DEPARTMENT OF
ECOLOGY
State of Washington

Second Tier Review Recommendation Document for

**Microsoft Oxford Data Center
Quincy, Washington**

August 12, 2014 (Updated)

Figure 2. Receptor locations in relation to estimated DEEP concentrations (assuming both filterable and condensable fractions represent DEEP). Concentrations are reported as the number of times higher than the ASIL.

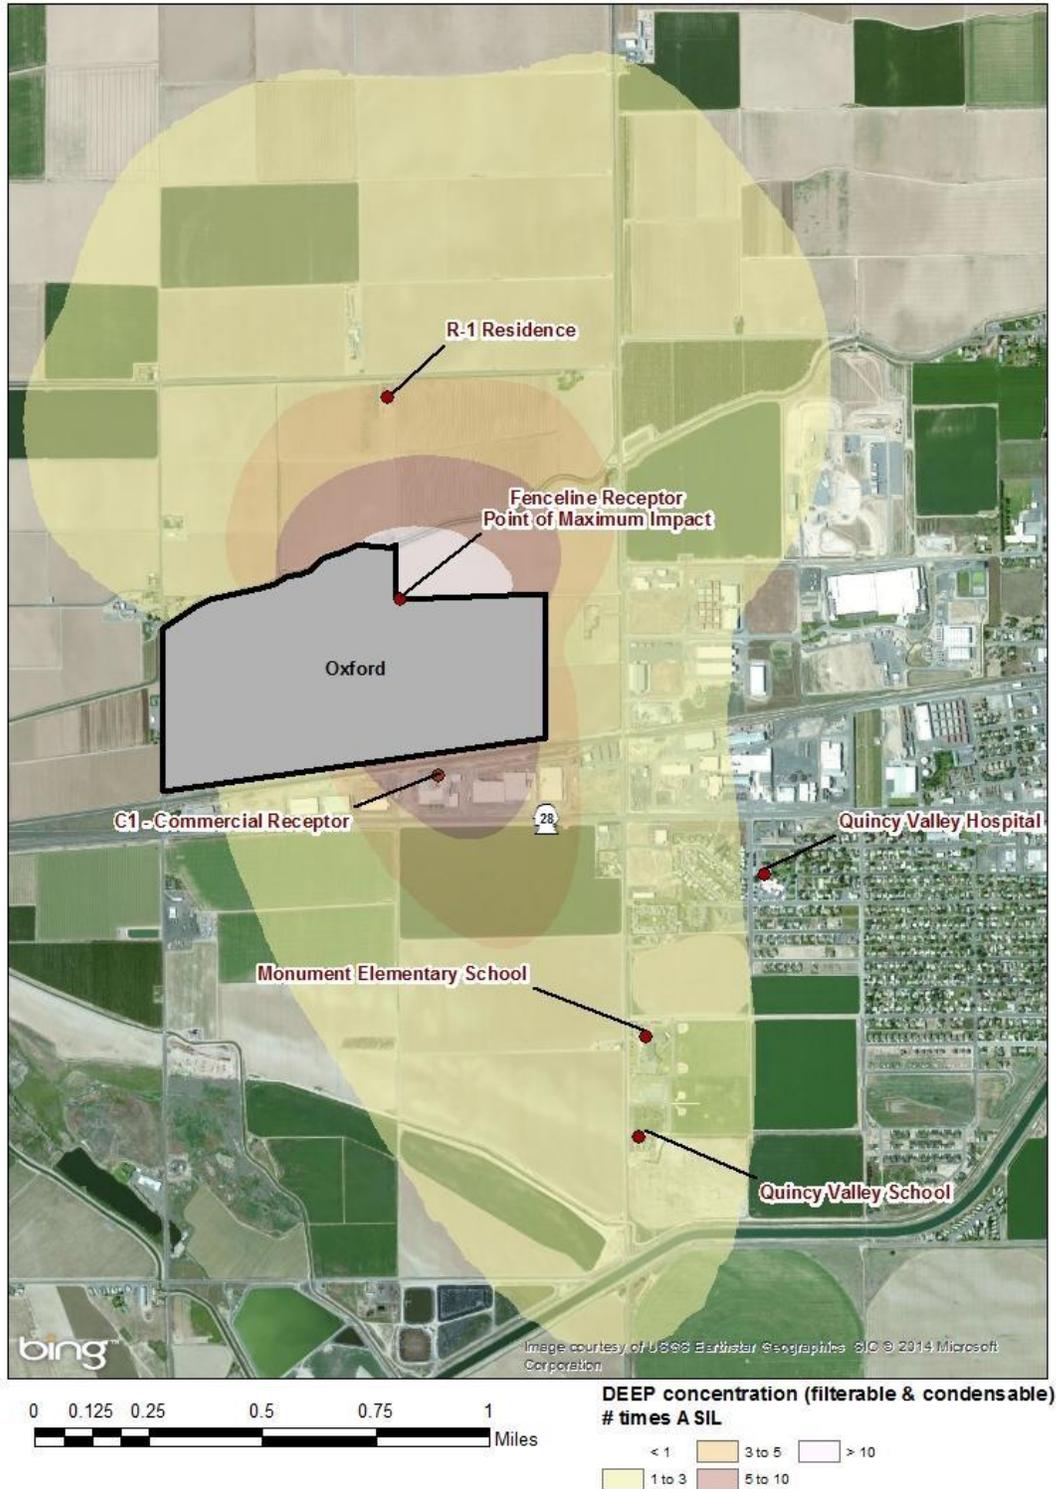
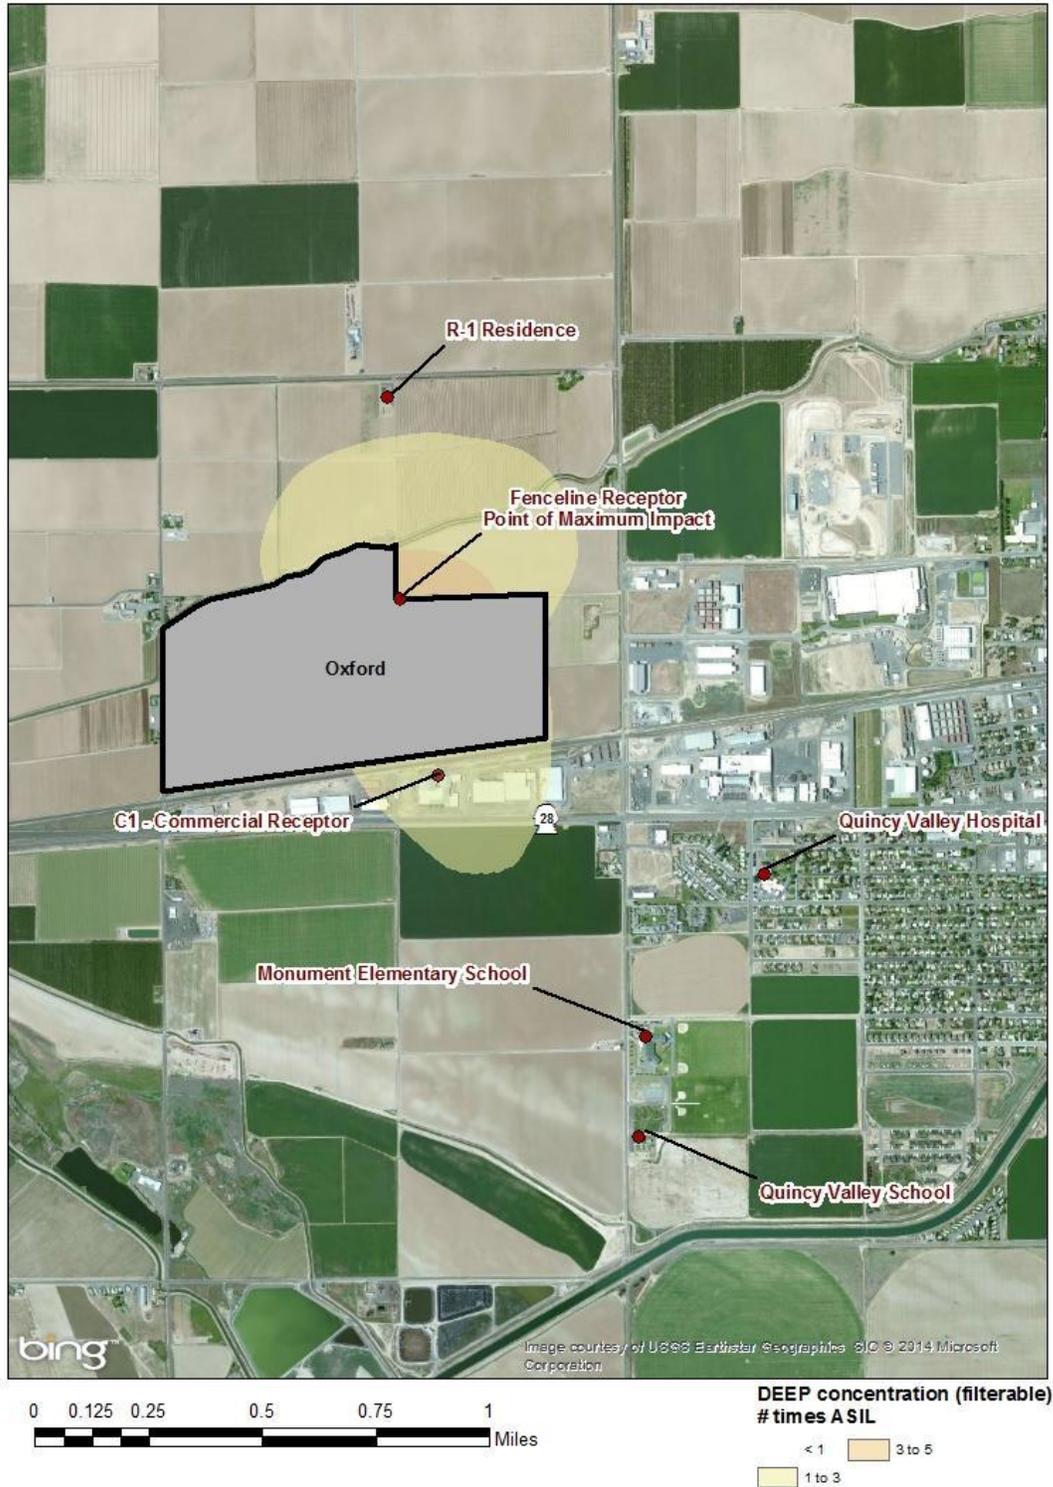
Ecology’s review of the HIA found that Landau identified appropriate receptors to capture the highest exposures for residential, commercial, and fence line receptors. Landau also identified other potential sensitive receptor areas such as students at Monument Elementary and Quincy Valley Schools, and patients at Quincy Valley Hospital (Figures Figure 2 and Figure 3).

Figure 5. Estimated maximum 1-hr NO₂ concentrations resulting from cumulative NO_x emissions of all permitted and proposed data center engines during a simultaneous outage in Quincy. These maximum concentrations do not all occur at the same time.

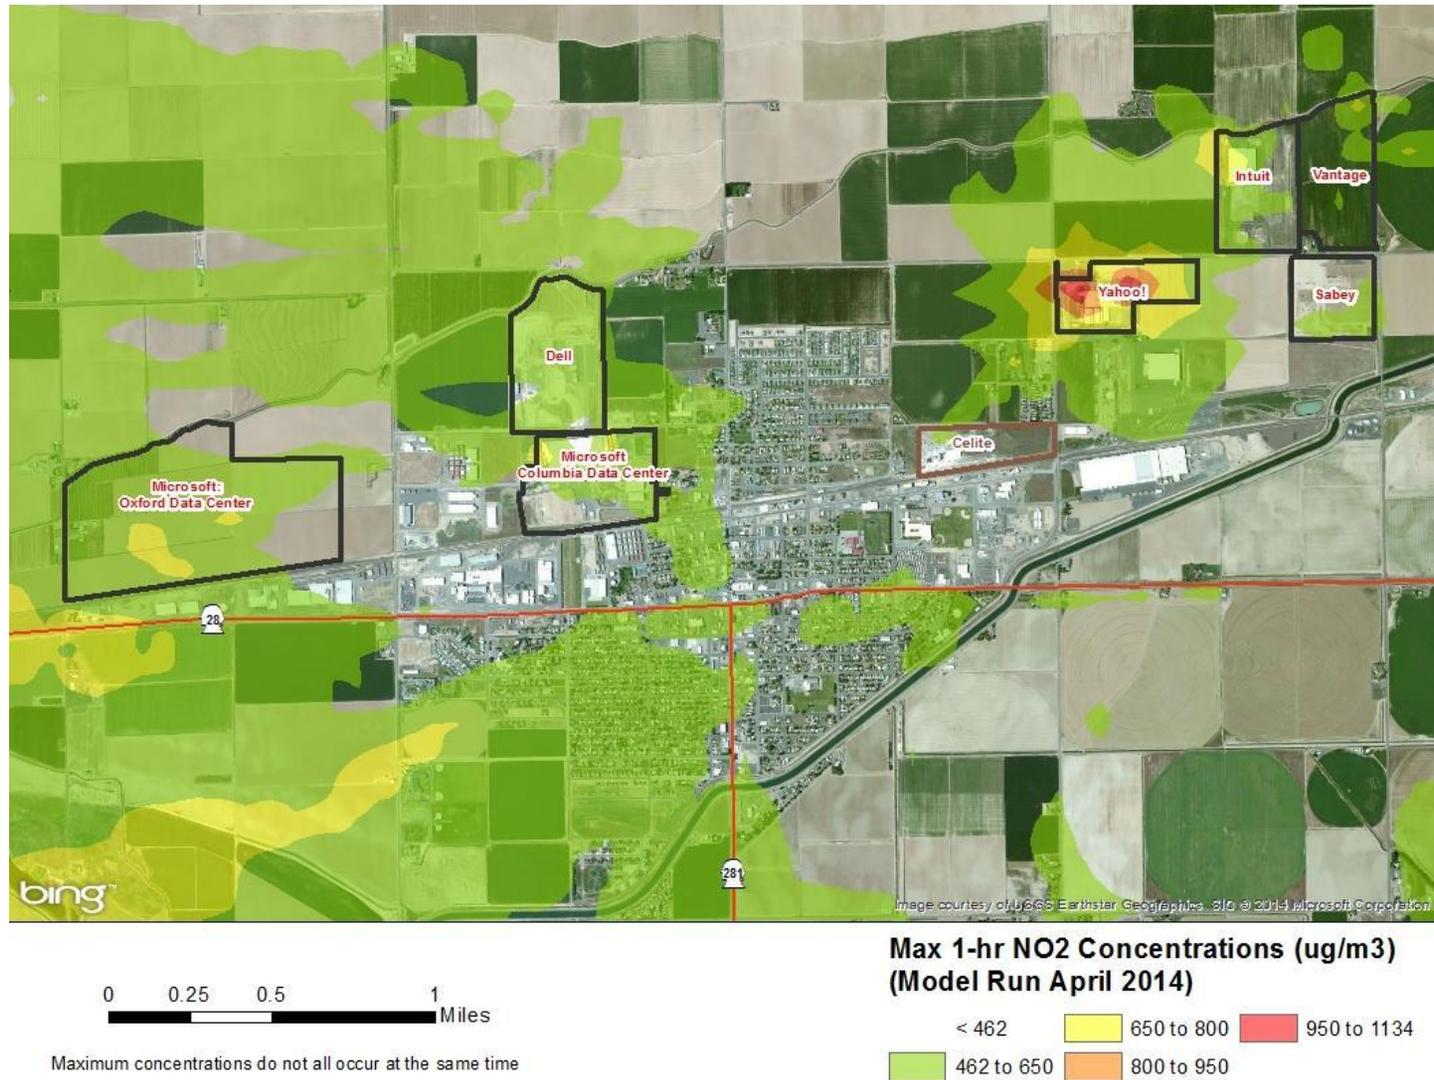
Figure 5 shows the maximum 1-hour NO₂ concentrations that could occur in Quincy if all data centers operated simultaneously under emergency conditions. Although the acute reference exposure level for NO₂ is 470 µg/m³ (CalEPA, 2008), the figure shows only those concentrations that exceed 462 µg/m³ because Ecology assumes that a NO₂ background concentration of 8.3 µg/m³ exists in Quincy at any given time (NW AIRQUEST, 2014). It is important to note that the maximum 1-hour concentrations shown in Figure 5 do not all occur at the same time. The figure displays the worst-case concentration at each location in Quincy. Generally, this figure shows that concentrations of NO₂ could exceed a level of health concern in some areas of Quincy.

Figure 6. Estimated number of times per year that 1-hr NO₂ concentrations could exceed 462 ug/m³ assuming continuous outage emissions for an entire year.

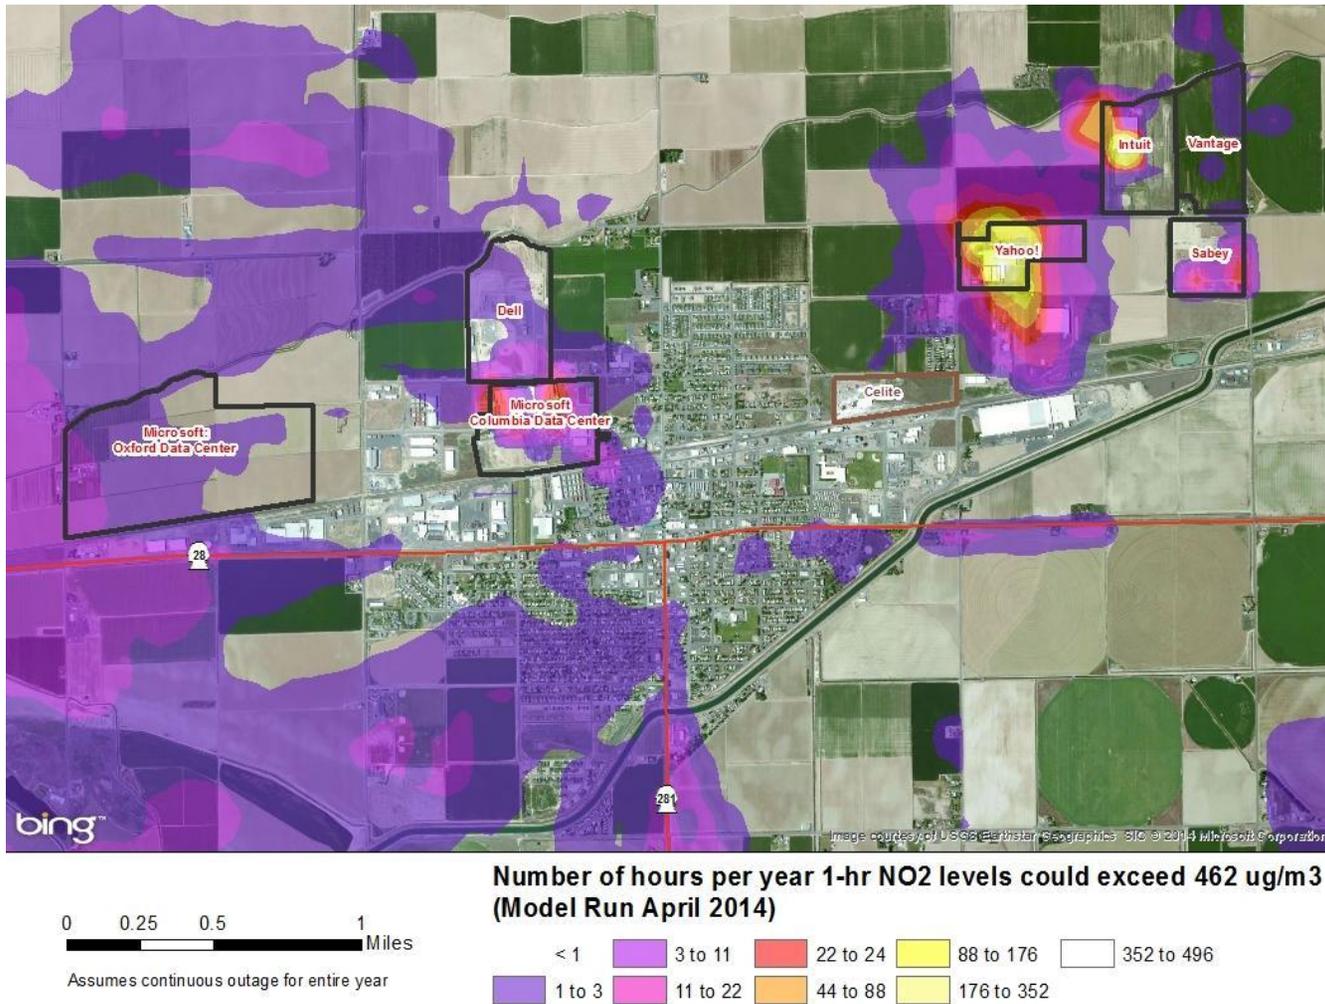
Ecology also analyzed the frequency (# of hours per year) meteorological conditions could result in a NO₂ concentration greater than 462 µg/m³ at each receptor point within the Quincy modeling domain. Figure 6 shows the number of hours per year that a cumulative NO₂ concentration could exceed 462 µg/m³ assuming data center engines operate during all combinations of meteorological conditions experienced throughout the year. If engines were run continuously during the course of a year, some areas near data centers could achieve concentrations of health concern for up to about 300 hours per year. In reality, these data centers were not permitted to continuously operate their engines; instead, they are only permitted to operate between eight and 400 hours per year under emergency outage conditions. Grant County Public Utilities District (PUD) reported that from 2003 to 2009, the average total outage time for customers that experience an outage throughout PUD's service area is about 143 minutes per year (Coe, 2010).
